PIC18F24K20/25K20/44K20/45K20 Silicon Errata and Data Sheet Clarification

The PIC18F24K20/25K20/44K20/45K20 devices that you have received conform functionally to the current Device Data Sheet (DS41303G), except for the anomalies described in this document.

The following typographic corrections and clarifications are to be noted for the latest version of the device data sheet (DS41303G):

Microchip Technology Drawing C04-156A Sheet 1 of 2

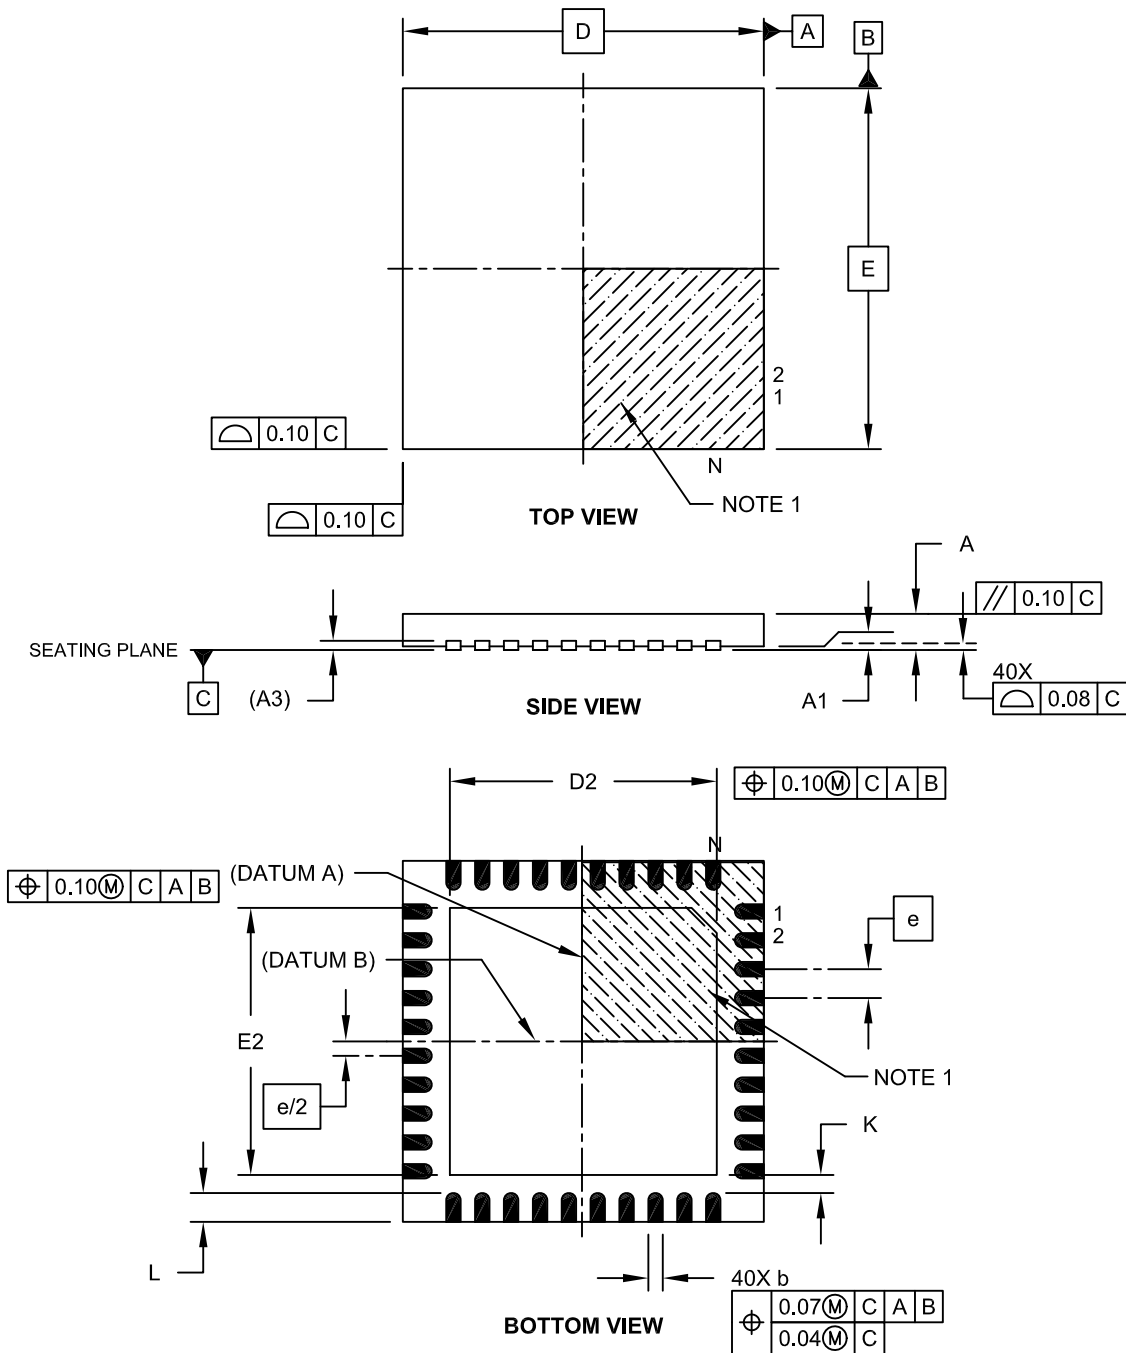
1. Module: Dimensions for UQFN Packaging Option

The packaging information for the 40-pin UQFN is the following:

40-Lead Ultra Thin Plastic Quad Flat, No Lead Package (MV) – 5x5x0.5 mm Body [UQFN]

Microchip Technology Drawing C04-156A Sheet 2 of 2

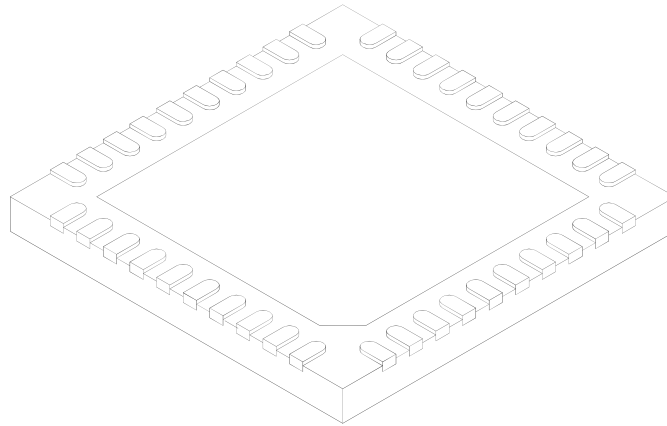
40-Lead Ultra Thin Plastic Quad Flat, No Lead Package (MV) – 5x5x0.5 mm Body [UQFN]

FIGURE 26-1: 40-PIN DIAGRAM UQFN

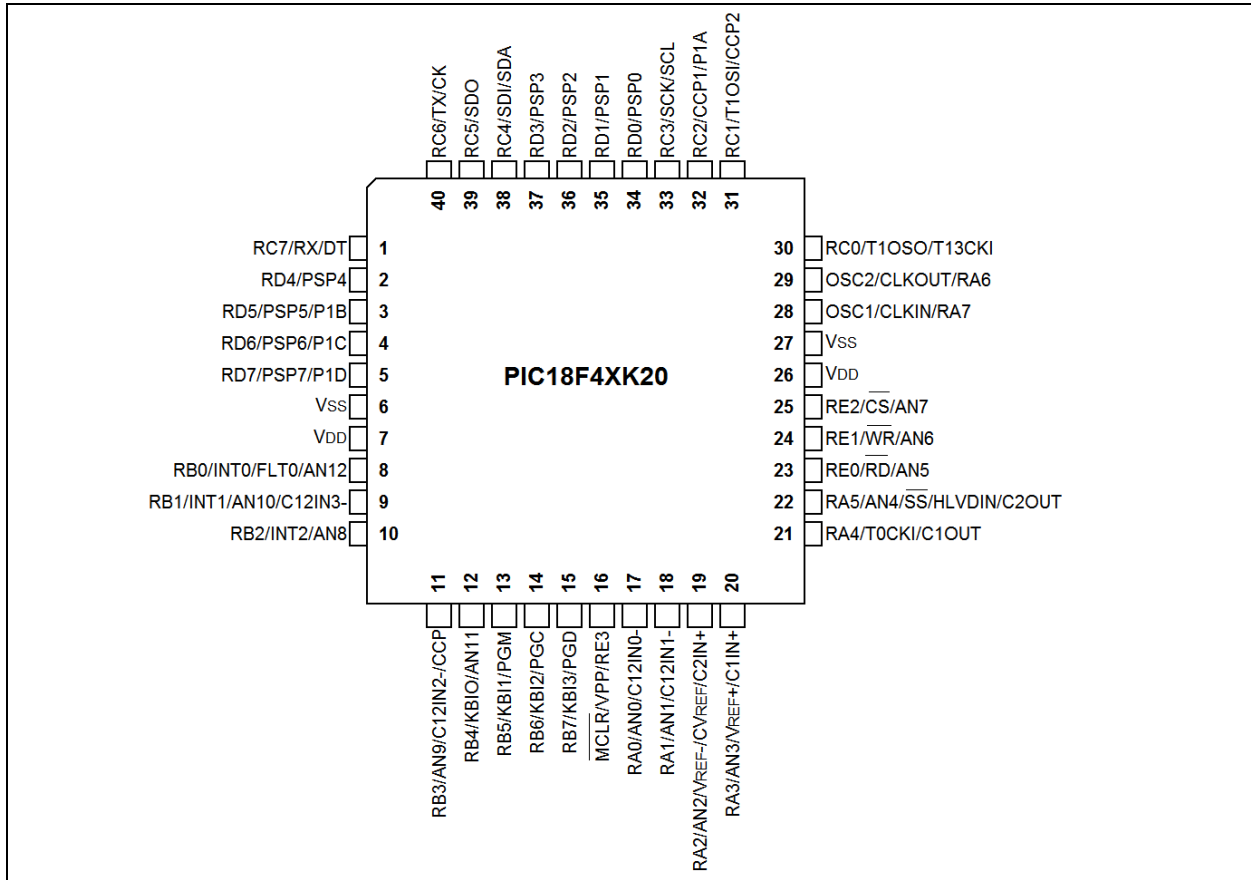
3. Module: Pin Diagram 40-pin UQFN

A new 40-pin UQFN diagram has been added to the data sheet (see [Figure 26-1](#)).

7. Module: Package Marking Information

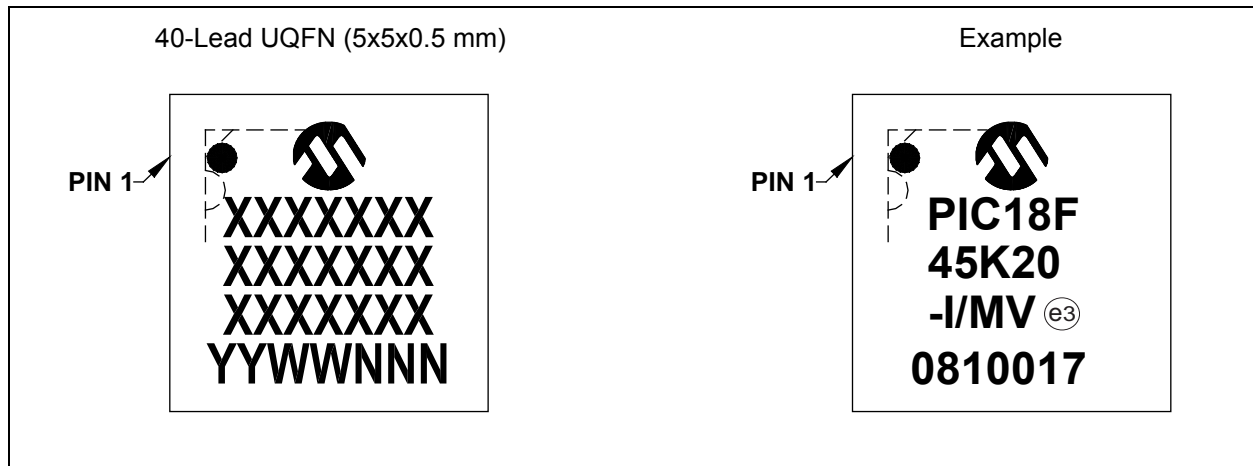
The package marking information for the 40-pin UQFN is the following:
